SUNDRY NOTICES AND REPORTS ON WELLS
Do not use this form for proposals to drill or to re-enter an abandoned well. Use Form 3160-3 (APD) for such proposals.

8. Well Name and No.
CROOKED BILL FEDERAL #1

SCHEMATIC PRIOR TO PLUG AND ABANDON
JALAPENO CORPORATION
CROOKED BILL FEDERAL NO. 1
CHAVES COUNTY, NEW MEXICO
API NO. 30-005-64156

Permanent Abandonment of Federal Wells Conditions of Approval

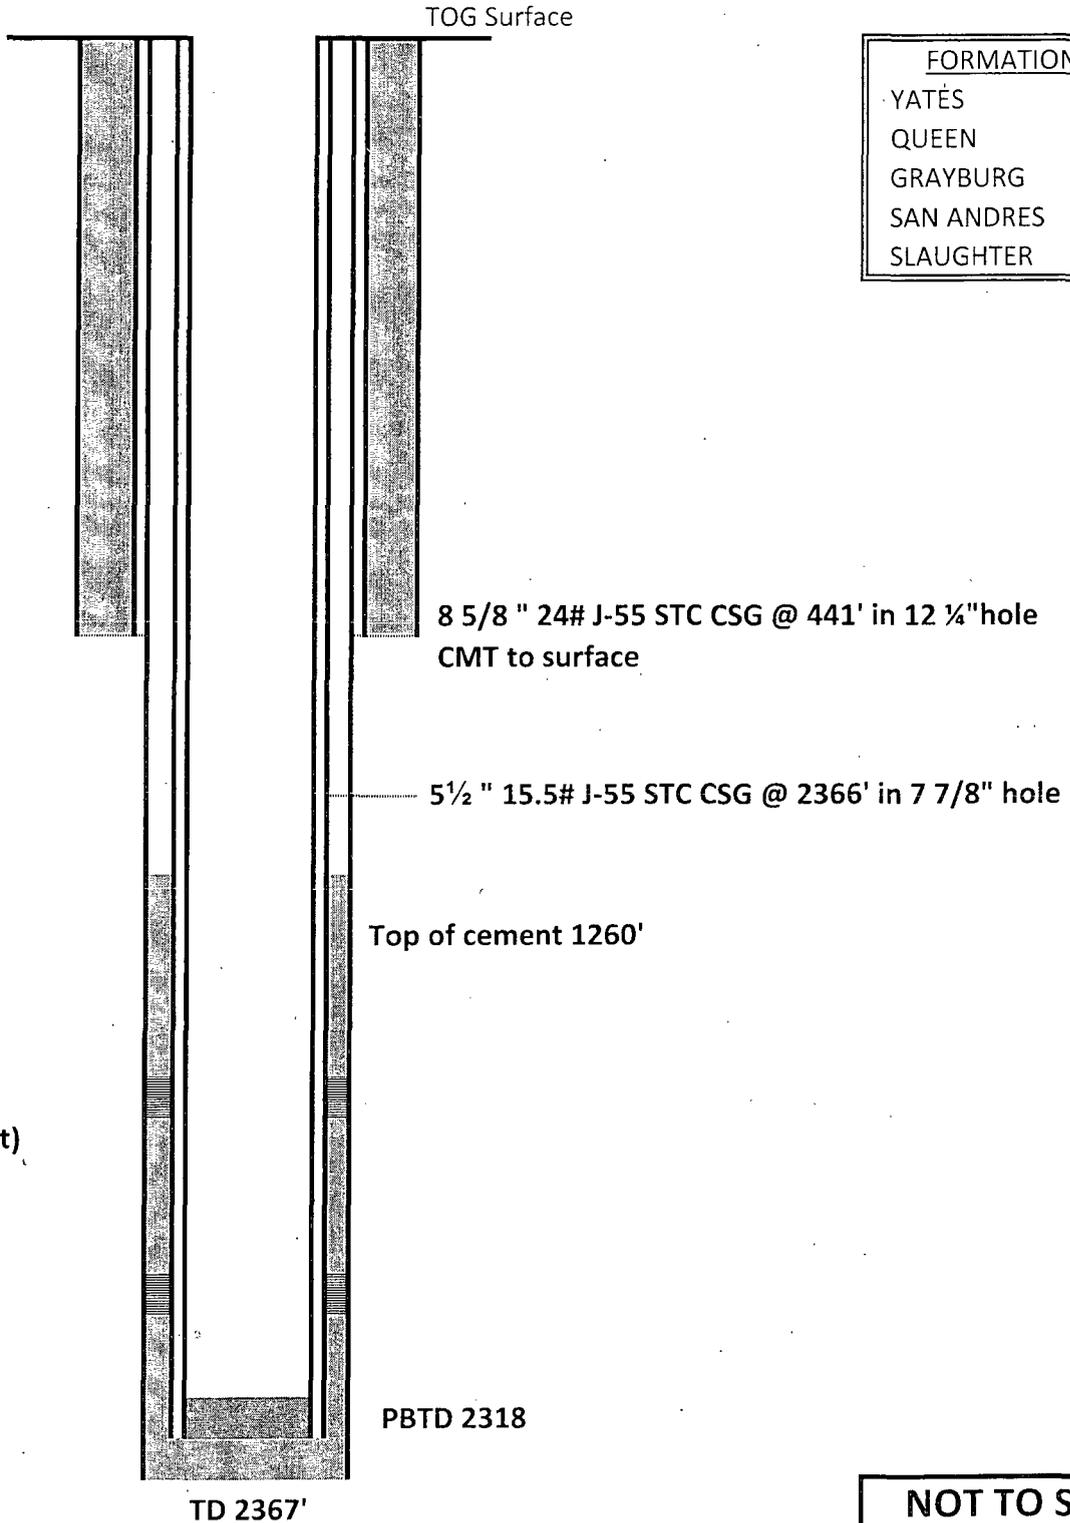
1. Set a Cement Plug from PBTD to 50ft above top perforations (appr. 2220'-2318).
2. Wait for cement to dry and tag. *@ Or Above 2218' - Witness*
3. Set a Cast Iron Bridge Plug directly above Cement Plug and fill hole with mud 50 feet below Surface Shoe.
4. Perforate 50 feet below Surface Shoe and cement. *Circulate From 490' To Surface*
5. Wait for cement to dry.
6. Set dry hole marker.
